## REVISION TRANSMITTAL

FLIGHT CONTROLS - INSPECTION OF THE AFT ELEVATOR SECTOR BOLT FOR CORRECT INSTALLATION

680A (Citation Latitude)

SL680A-27-08  
Page 1 of 6

Figure 1. Inspection of the Aft Elevator Sector Bolt for Correct Installation (Sheet 1)

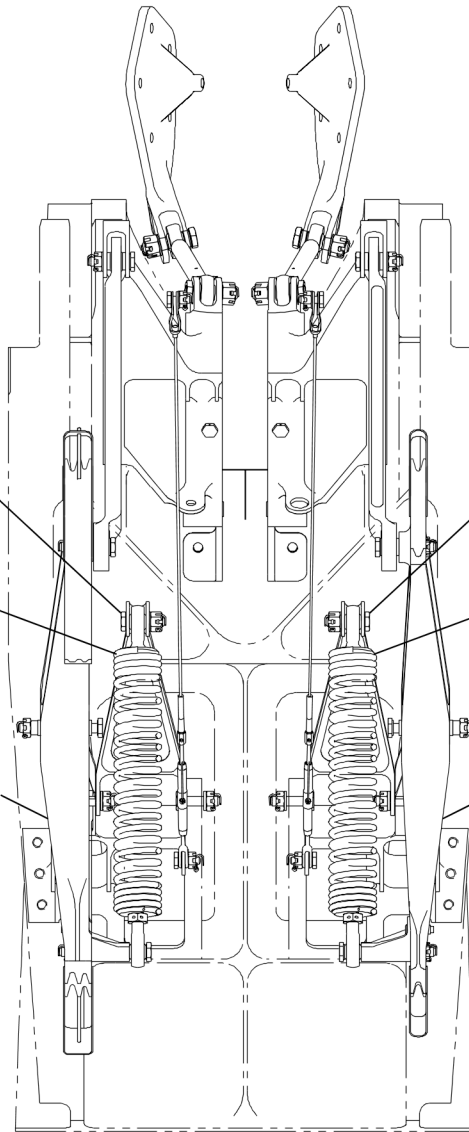
- L. Using a high intensity light, examine the upper bolts that attach the down spring to the aft elevator sector for correct installation (bolt head installed facing outboard).

- (2) On aircraft where the examination revealed the upper bolt was not installed correctly (bolt head installed facing inboard), do the steps that follow:

- (e) Install the kept bolts with the head of the bolts facing outboard.
  - (f) Install the washers and nuts.
  - (g) Torque the bolts. (Refer to the Citation Standard Practices Manual, Chapter 20, Torque Data - Maintenance Practices.)

**NOTE:** The NAS6204-10D Bolt should be installed with the bolt head facing outboard.

Figure 1. Inspection of the Aft Elevator Sector Bolt for Correct Installation (Sheet 2)

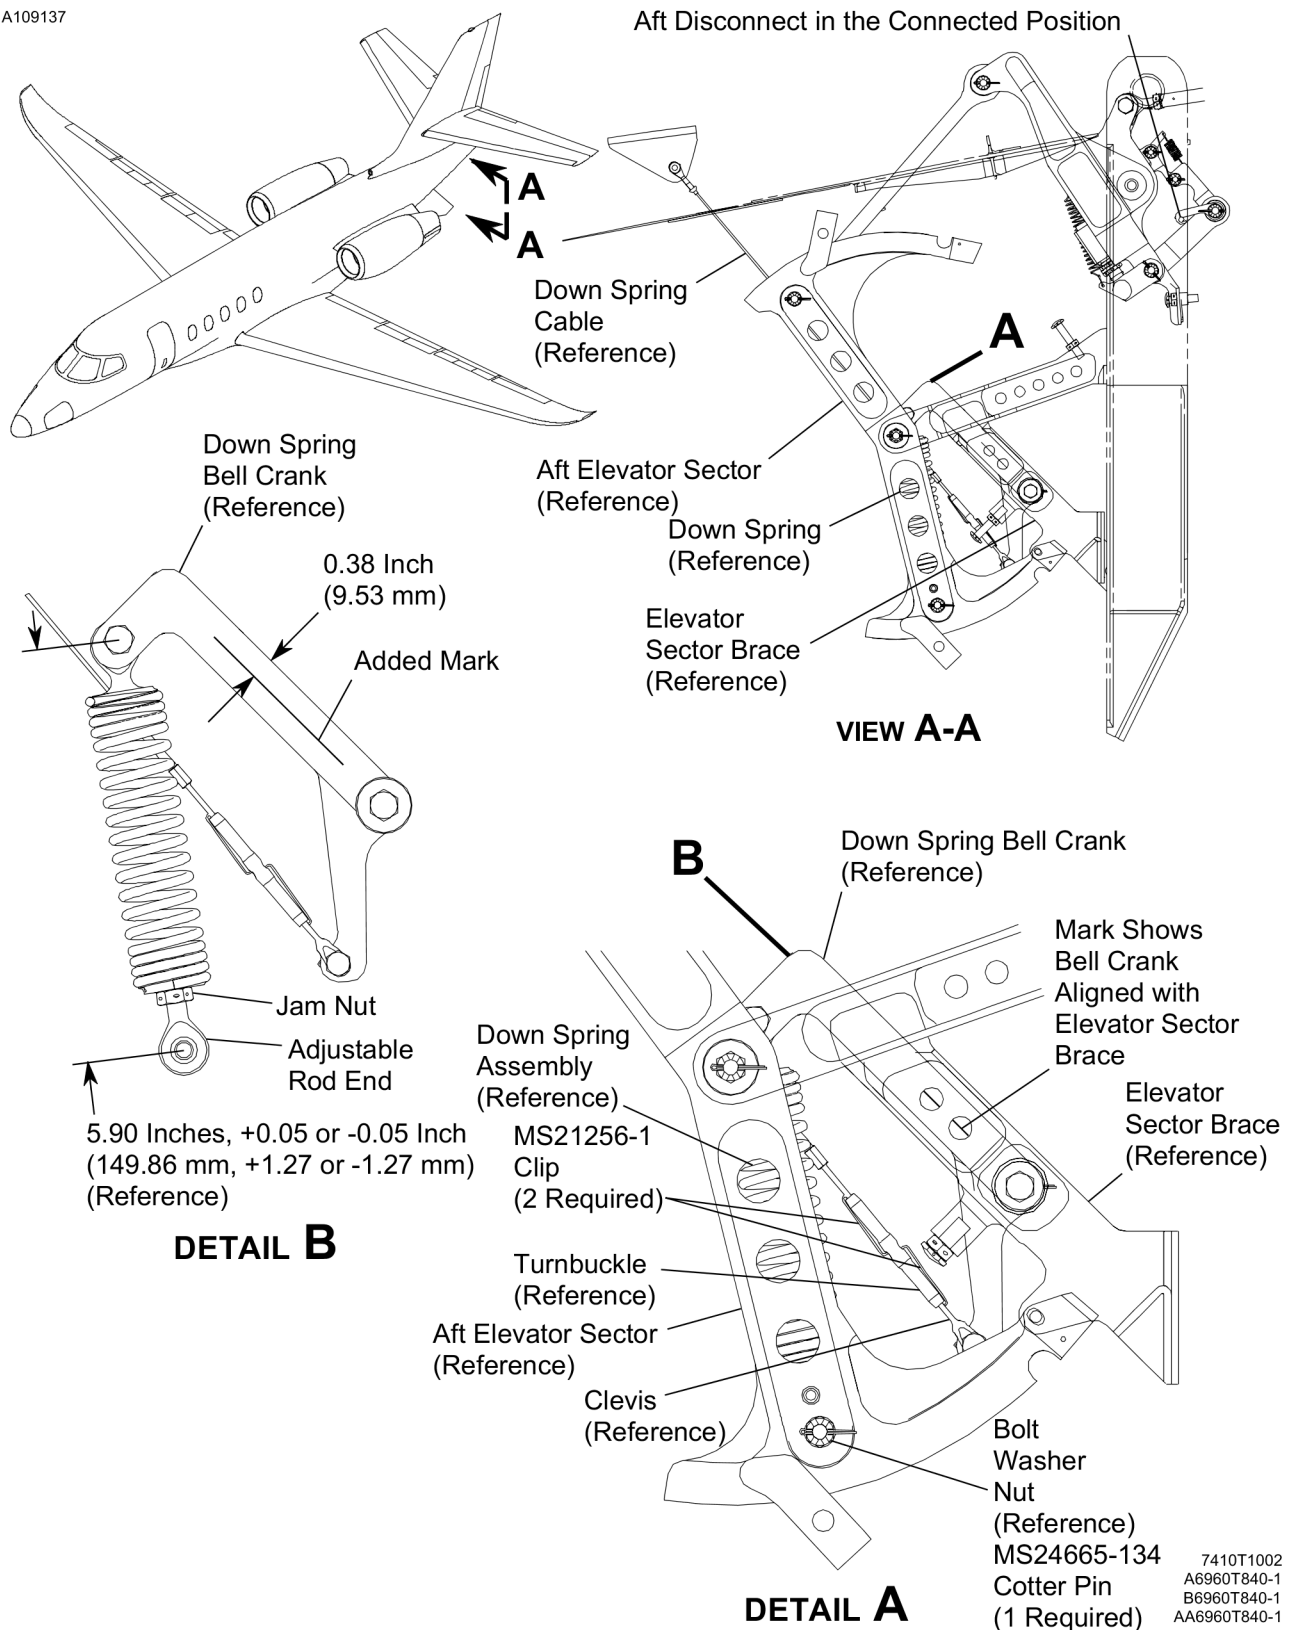
- (i) (Refer to Figure 2, Sheet 1.) If not already done, using an indelible marker, make a mark along the center line of both down spring bell cranks.

- (j) Adjust the down spring cable turnbuckles until the marks on both down spring bell cranks are aligned with the center of the holes in the aft elevator sector brace.
